Friday, 3 July 2020

Re: Omaroro Reservoir – Request for Variation to Licence Agreement

Attachment 1: Locations of Variation Areas

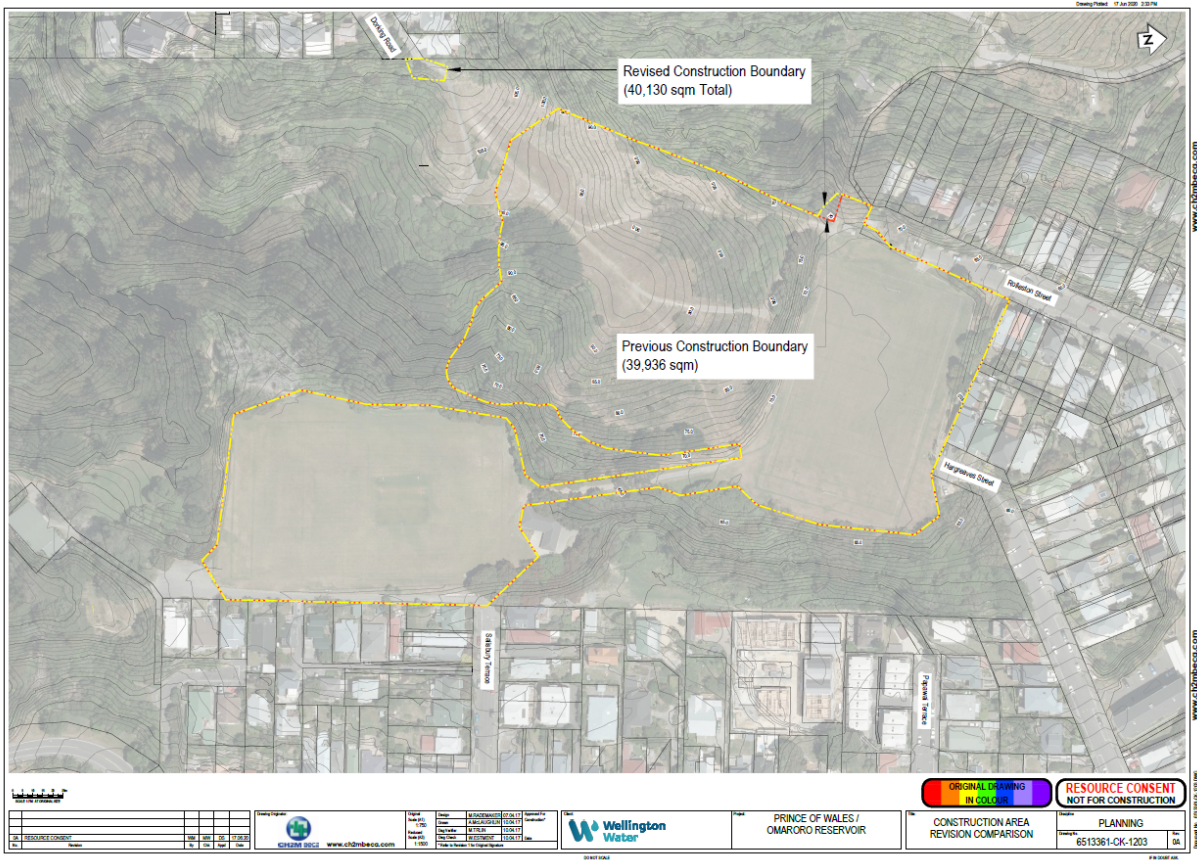
These proposed works would change the licence area in two locations, including the top of Dorking Road and the top of Rolleston Street. These two areas are shown in **Attachment 1**.

Mitigation and off-setting for the variation shall include:

- **Access via Dorking Road not to be allowed during the construction of the Reservoir project.**
- **Implementation of a tree protection for the Totara tree on Dorking Road and planting in the area of Town Belt and Road reserve**

- **Additional planting along the edges of the Waitangi Stream tributary**
- **Implementation of mitigation and erosion and sediment control measures to ensure protection of the tributary of the Waitangi Stream.**
